Groundwater Transfer Review Summary Form

Transfer/PA # T- 14581

Application: T-14581

Applicant Name: Jensen Family LLC c/o Mark Tribbett

Injury Analysis

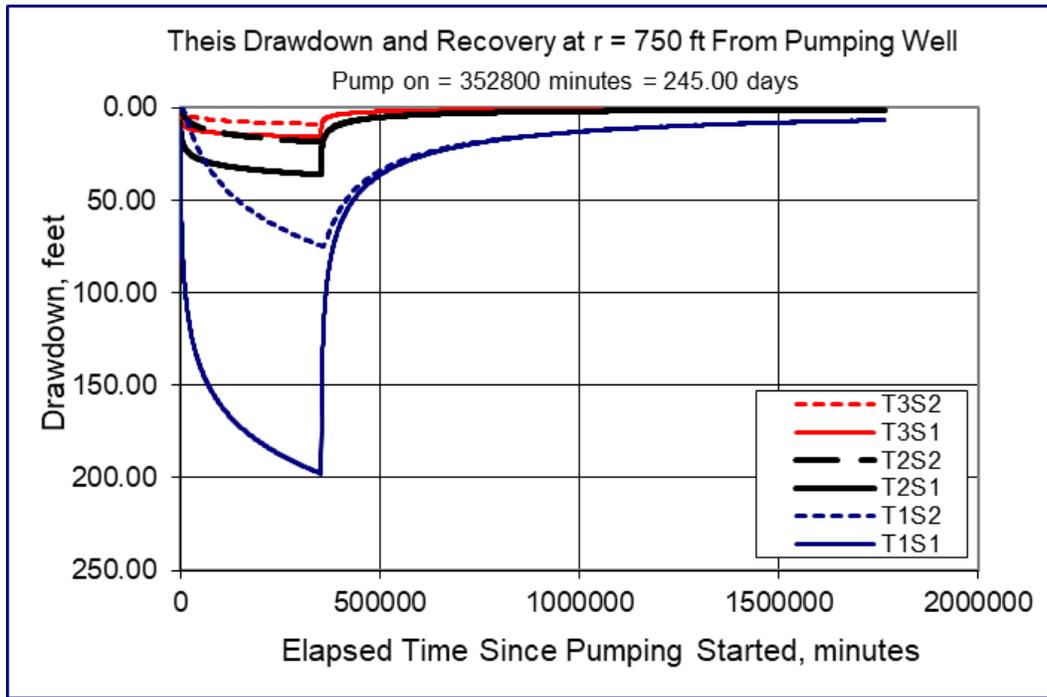
5. a) Will this proposed change, at its maximum allowed rate of use, likely result in an increase in interference with **another ground water right**?
 Yes No Comments: Proposed APOA 3/Well 3 (PROP 609) is ~750 ft northwest of MARI 6489, a POA on Certificate 47840 with priority date 5/23/1973. The authorized POA/POA 1 (MARI 6493) is ~1956 ft southwest of MARI 6489. The reduced distance is anticipated to increase interference with MARI 6489.

- b) If yes, would this proposed change, at its maximum allowed rate of use, likely result in another groundwater right not receiving the water to which it is legally entitled?
 Yes No If yes, explain: The maximum drawdown produced by APOA 3/Well 3 (PROP 609) is not anticipated to result in MARI 6489 not receiving the water to which it is legally entitled.

Radial distance from pumping well (r)=750 ft [estimated radial distance to nearest user, MARI 6489]

Pumping Rate (Q)= 1.0356 cfs (~464.78 gpm)*

Aquifer Transmissivity (T1)= 1,497 gpd/ft (200 ft²/day), (T2)= 4,115 gpd/ft (550 ft²/day), (T3)= 32,060 gpd/ft (4,286 ft²/day)

Storativity (s1) = 0.0003, (s2) = 0.02 [Conlon et al 2005, Table 1 values for MSU]

Total pumping time= 245 days [March 1-October 31]

*The full pumping rate could not be utilized continuously for the entire 245-day period of use without exceeding the 503.25 ac-ft maximum allowed duty. For the maximum allowed duty of 503.25 ac-ft, continuous pumping would occur for 245 days at a rate of 1.0356 cfs (~464.78 gpm)

208	ft amsl	elevation
SWL	35	ft bls	MARI 6489
Aquifer Bottom	200	ft bls	Gannett & Caldwell 1998 (MARI 6489 is 195 ft depth, essentially fully penetrates the aquifer)
<hr/>			
Available Water			
Column	165	ft	Aquifer Bottom - SWL
<hr/>			
Pump Height Above			
Bottom	5	ft	Estimate
NPSHa	5	ft	Estimate
Driscoll estimate, Drawdown=Pumping Rate/Specific Capacity. For Cert 47840, rate is 0.84 cfs (377 gpm). From MARI 6489 well log, drawdown at 400 gpm was 66 ft and at 540 gpm was 95 ft for specific capacity of 6.06 and 5.68, respectively.			
Drawdown	66	ft	
<hr/>			
Minimum Water			
Column	76	ft	Estimated Drawdown + NPSHa + Pump Height
Injury	89	ft	Available Water Column-Minimum Water Column
